**KNOXVILLE/KNOX COUNTY METROPOLITAN PLANNING COMMISSION
 SUBDIVISION REPORT - CONCEPT/USE ON REVIEW**

▶ **FILE #:** 8-SD-09-C
 8-H-09-UR

▶ **SUBDIVISION:** WASHINGTON STATION
 ▶ **APPLICANT/DEVELOPER:** BENCHMARK ASSOCIATES
 OWNER(S): Douglas Dyer

PRELIMINARY LANDSCAPING PLAN
FOR USE ON REVIEW

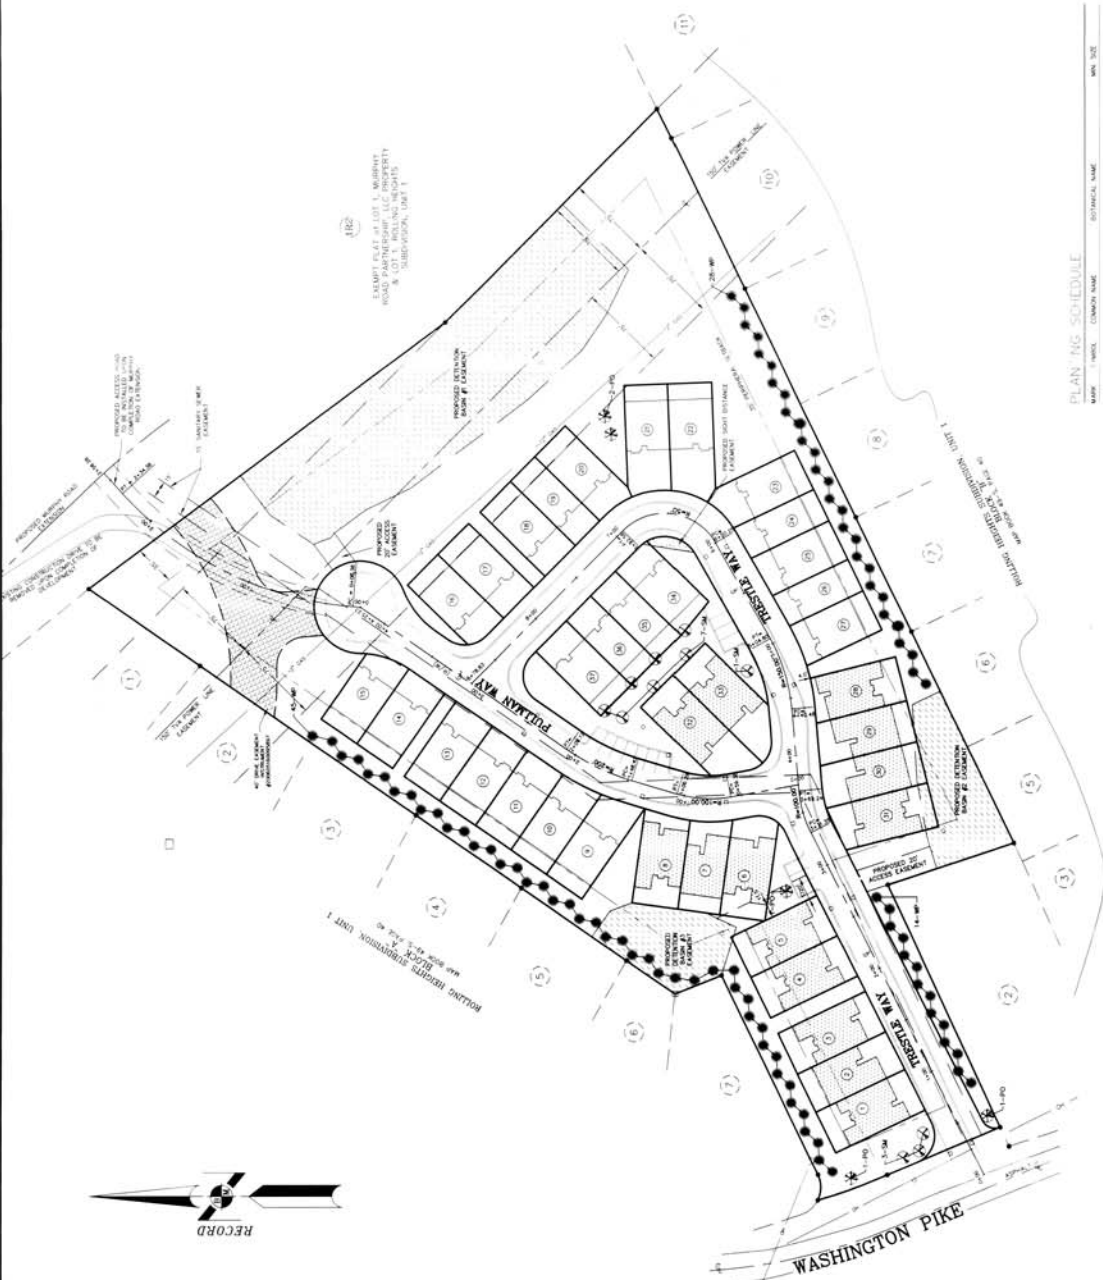
► **Approve the request for up to 37 attached residential units on individual lots as shown on the development plan subject to 4 conditions**

2. Providing a 3' front setback, 14' rear setback and a 0' side yard setback as shown on the development plan

3. Installing all landscaping, as shown on the development plan, within six months of the issuance of occupancy permits for this project, or posting a bond with the Knox County Dept. of Engineering and Public Works to guarantee such installation.

4.. A revised site plan reflecting the conditions of approval must be submitted to MPC staff prior to issuance of any building permits.
